ADDENDUM NO. 2 TO PROJECT NO. 42998

**CONSTRUCTION WORK, NVAC WORK, PLUMBING WORK, ELECTRIC WORK
REHABILITATE KITCHEN
AND DINING AREAS
GOSHEN RESIDENTIAL CENTER
97 CROSS ROAD
GOSHEN, NY 10924**

December 9, 2011

DRAWING NUMBER:
H-101

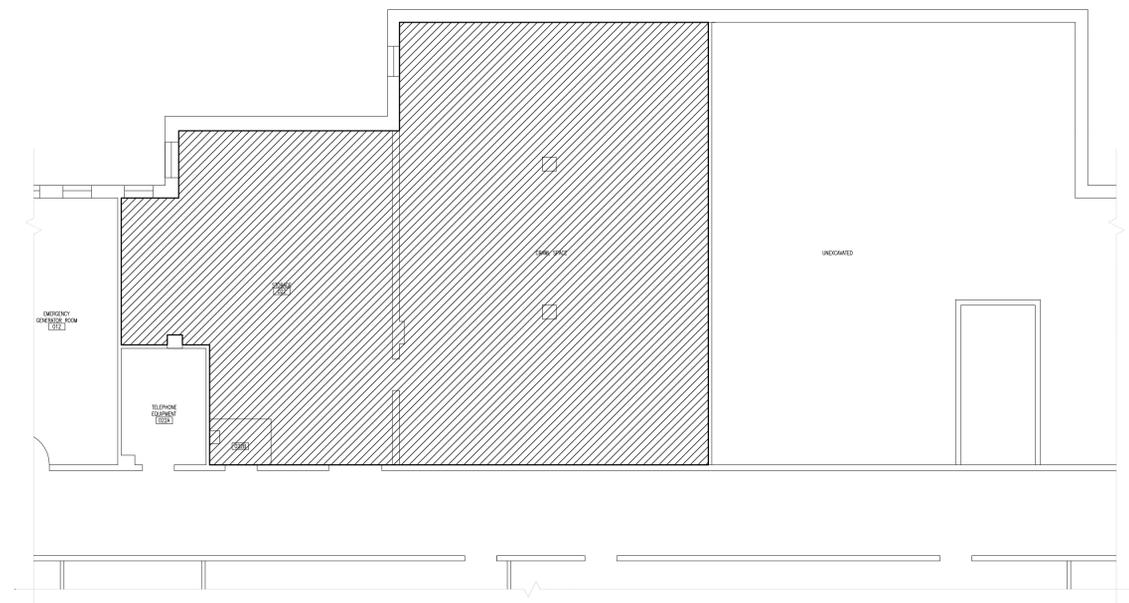
5. Revised Drawings:
 - a. Drawing H-001, dated "8 December 2011 Addendum" accompanies this Addendum and supersedes the same numbered originally issued drawing.
 - 1) Notes/quantities revised to include the pipe fitting removal in basement rooms 022, 022B, and adjacent crawlspace.
 - b. Drawing H-101, dated "8 December 2011 Addendum" accompanies this Addendum and supersedes the same numbered originally issued drawing.
 - 1) Drawing revised to include the pipe fitting removal in basement rooms 022, 022B, and adjacent crawlspace.

- THE REMOVAL OF ASBESTOS CONTAINING PIPE FITTING INSULATION ON FIBERGLASS IN-LINE FROM BASEMENT STORAGE ROOM 022, 022B, AND ADJACENT CRAWLSPACE AS DELINEATED ON DRAWING 2/H-101. TOTAL QUANTITY OF PIPE FITTING INSULATION TO BE REMOVED - 70 LF

ADD 1 - A101

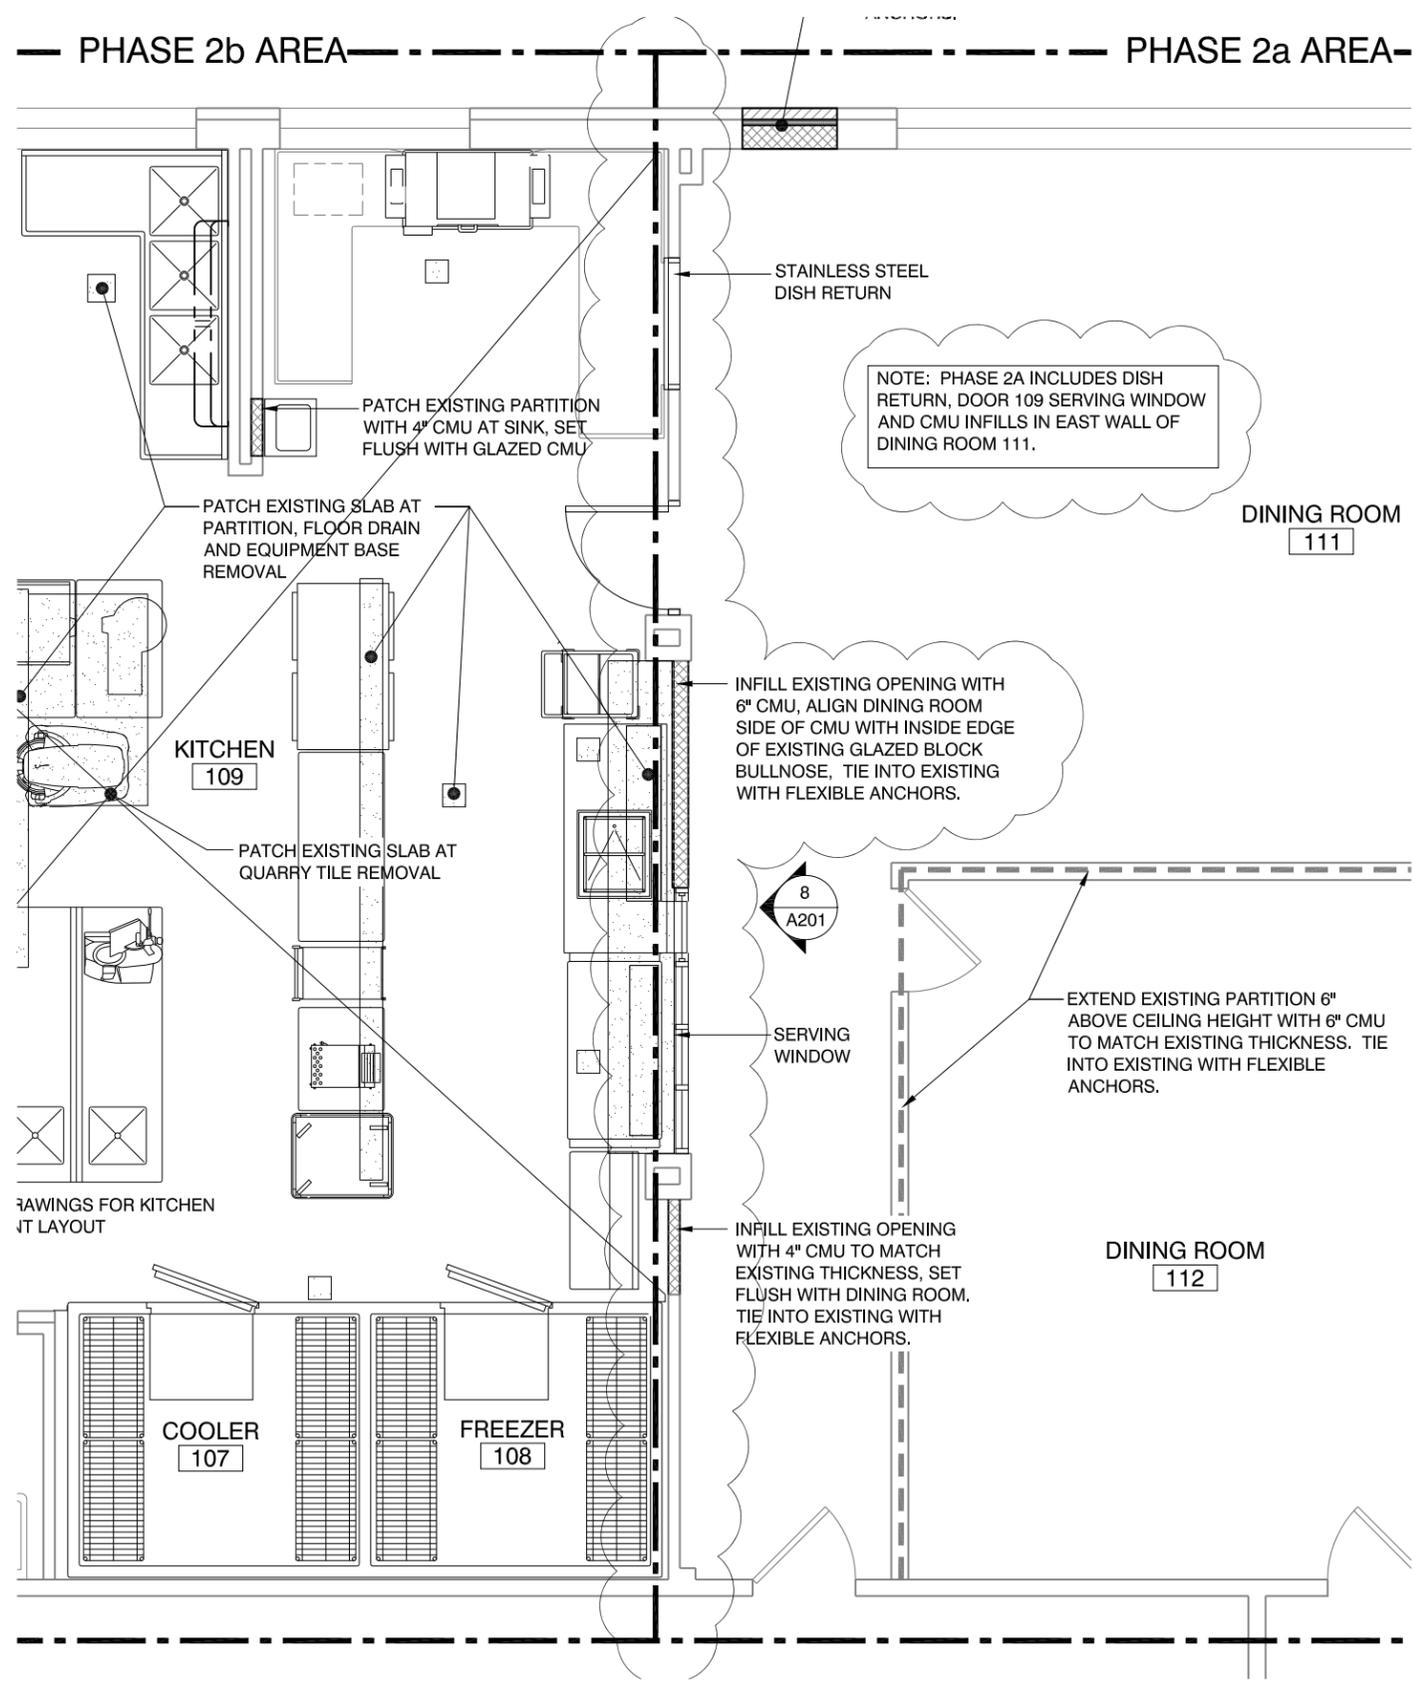
6. Drawing No. A-101:
 - a. Revise phasing limit line and floor plan at serving window per attached ADD 1 – A101.
7. Drawing No. A-201:
 - a. Replace detail 8/A-201 Serving Window with attached ADD 1 – A201 Revised Serving Window.
